**STATEMENT THAT A PROPOSAL MAY BE IMPLEMENTED  
(PURSUANT TO THE PROVISIONS OF THE  
ENVIRONMENTAL PROTECTION ACT 1986)**

**CAPE LAMBERT PORT B DEVELOPMENT -  
SHIRE OF ROEBOURNE**

## Attachment 1 to Ministerial Statement 840

### Change to Proposal

Environmental Protection Authority  
 Figure 5 : Amended Marine Component of proposal footprint

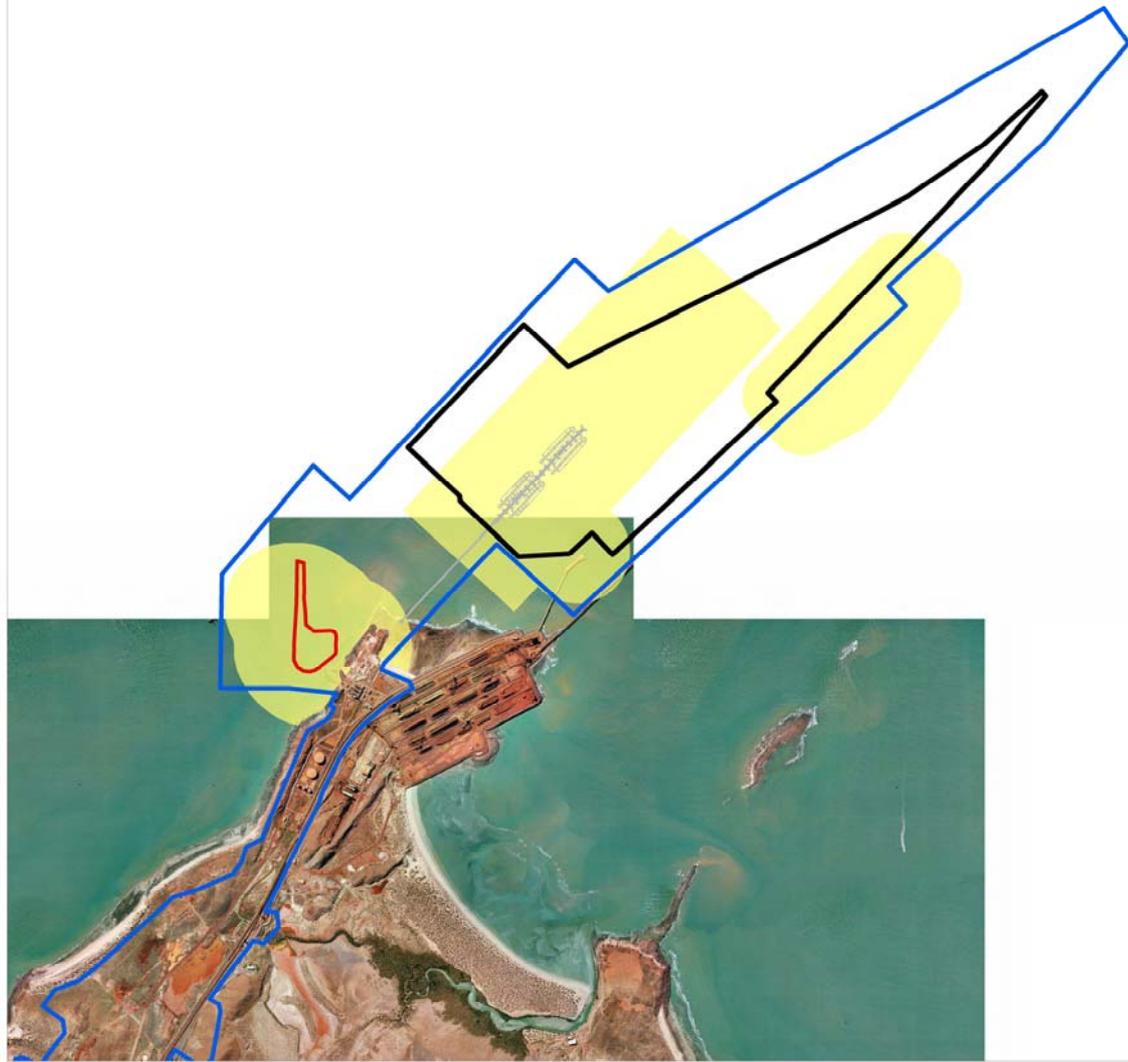
**Change:** Change to the Tug Harbour Extension dredging footprint area (i.e. updated Table 4 and Figures 2, 4b and 4c).

**Table 10 – Coordinates of Dredging Footprint – Small Dredge Area (datum and projection: GDA 1994 MGA zone 50)**

**Figure 6: Marine Component of Proposal Footprint**

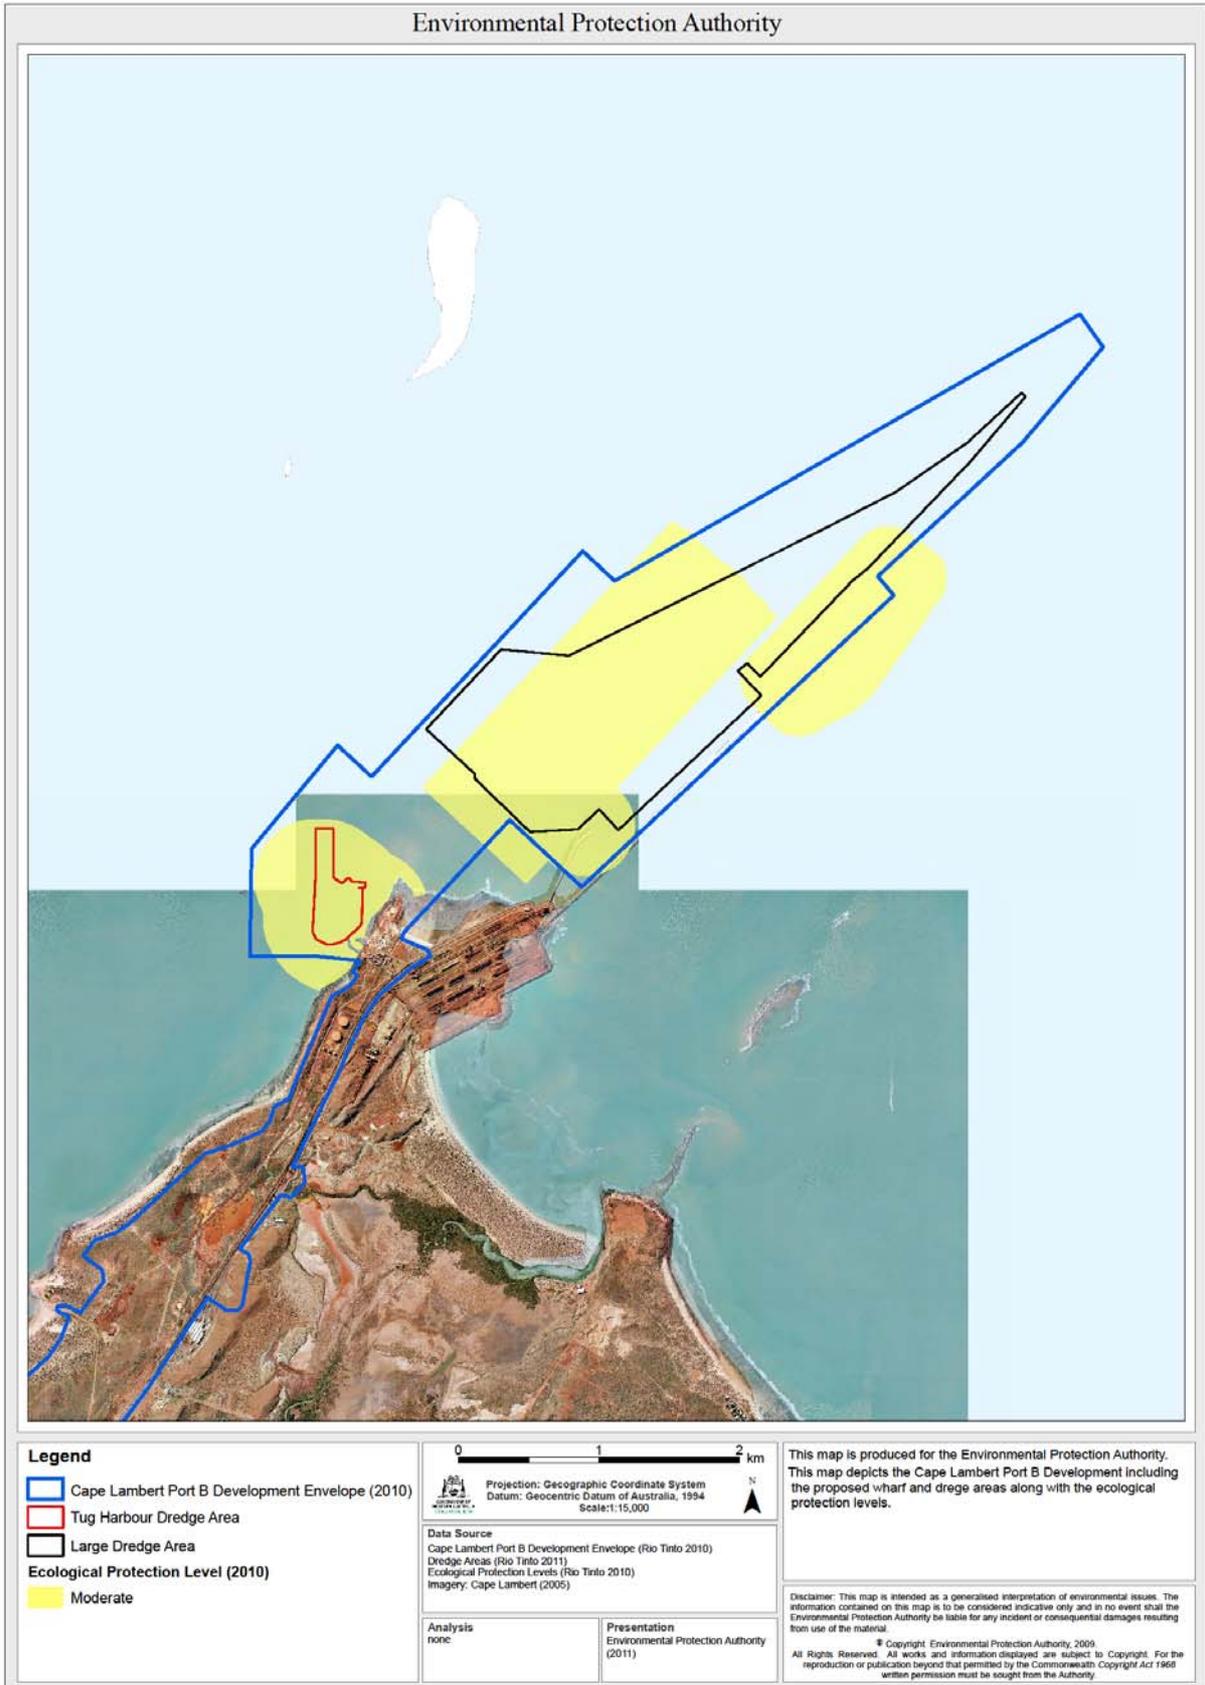
**Change:** Additional dredging – increase in “large dredge area” and “tug harbour dredge area” (replaced Figure 5, Table 4 and Key Characteristics Table).

**Table 11a. Coordinates of Dredging Footprint – Tug Harbour (Small Area)**

**Figure 7: Terrestrial Component of Proposal Footprint**

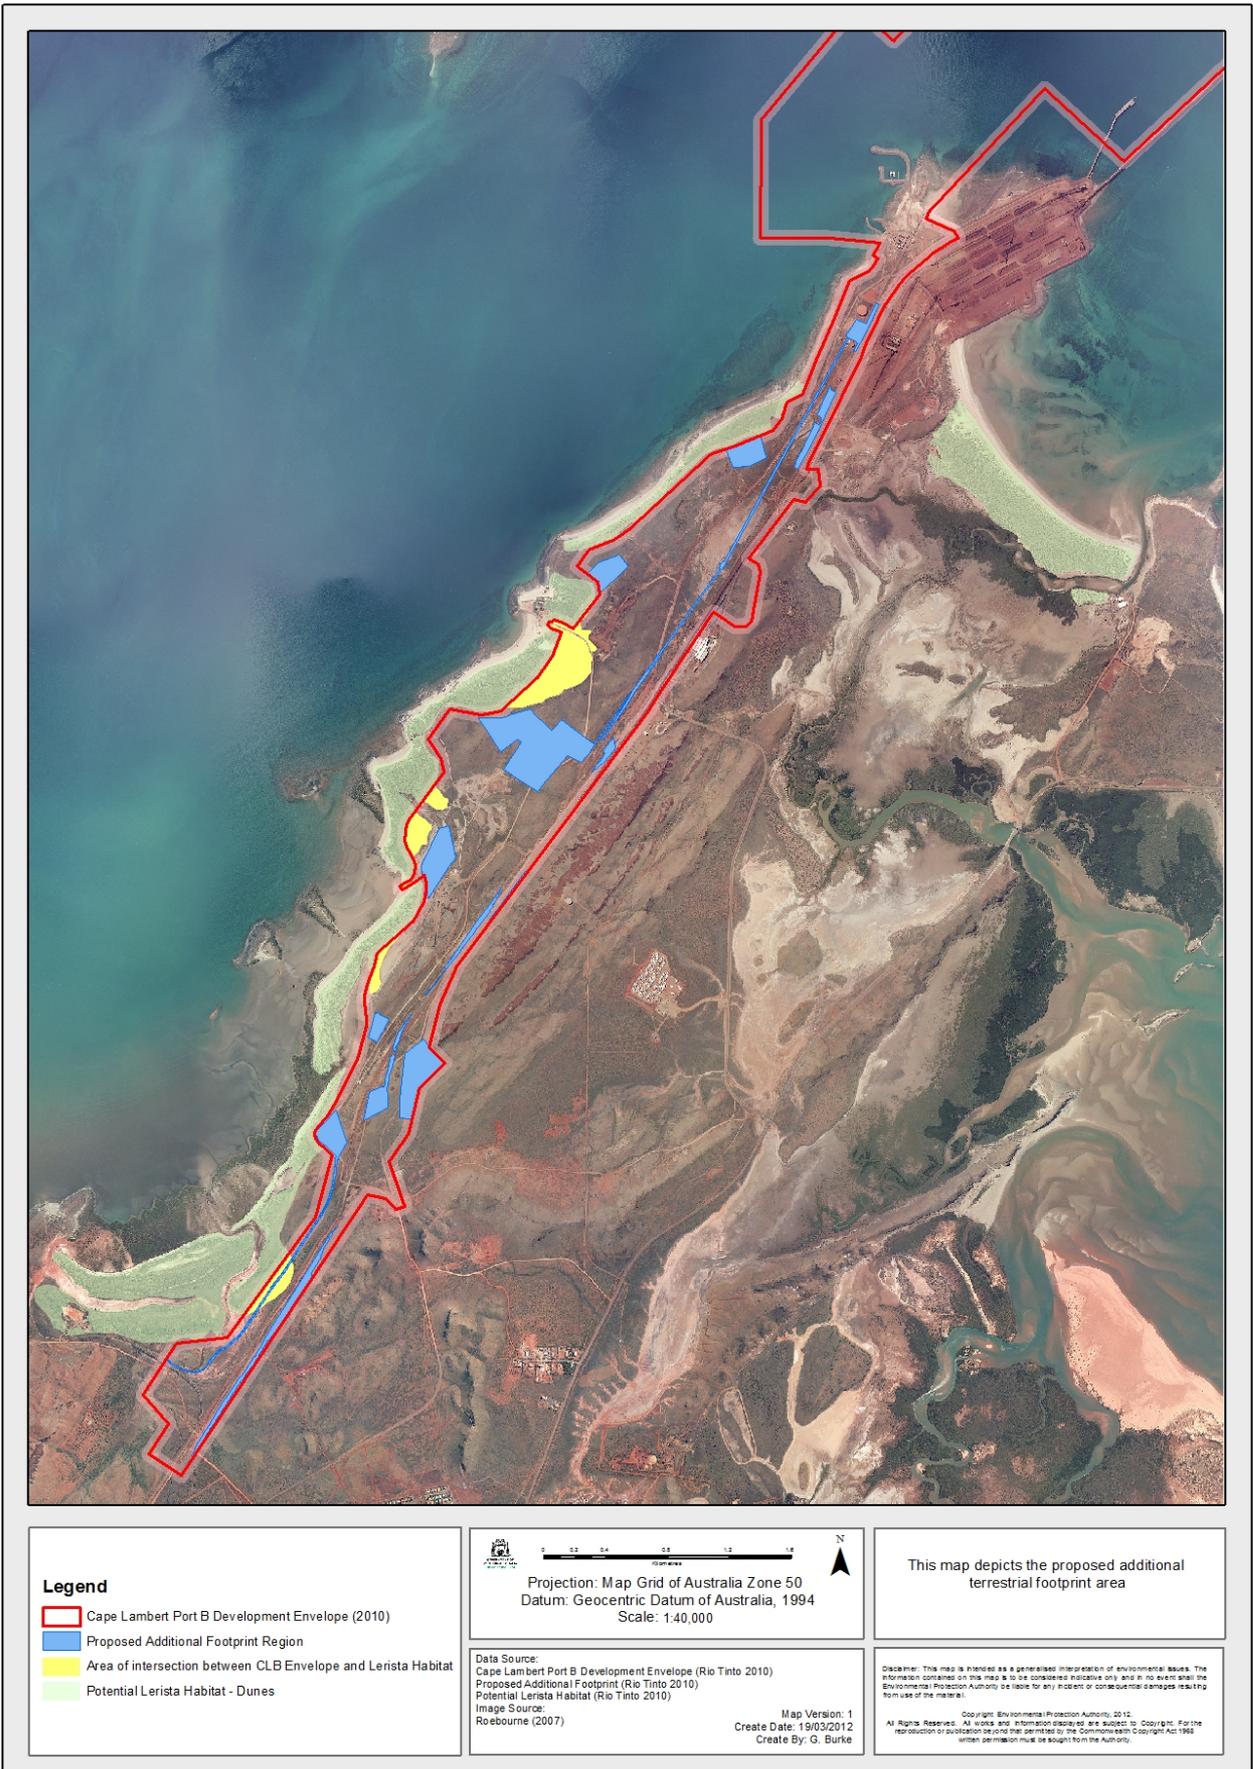
**Change:** Additional clearing – Additional 46 ha of terrestrial clearing. Inclusion of figure 7 depicting Terrestrial Component of the Proposed Footprint
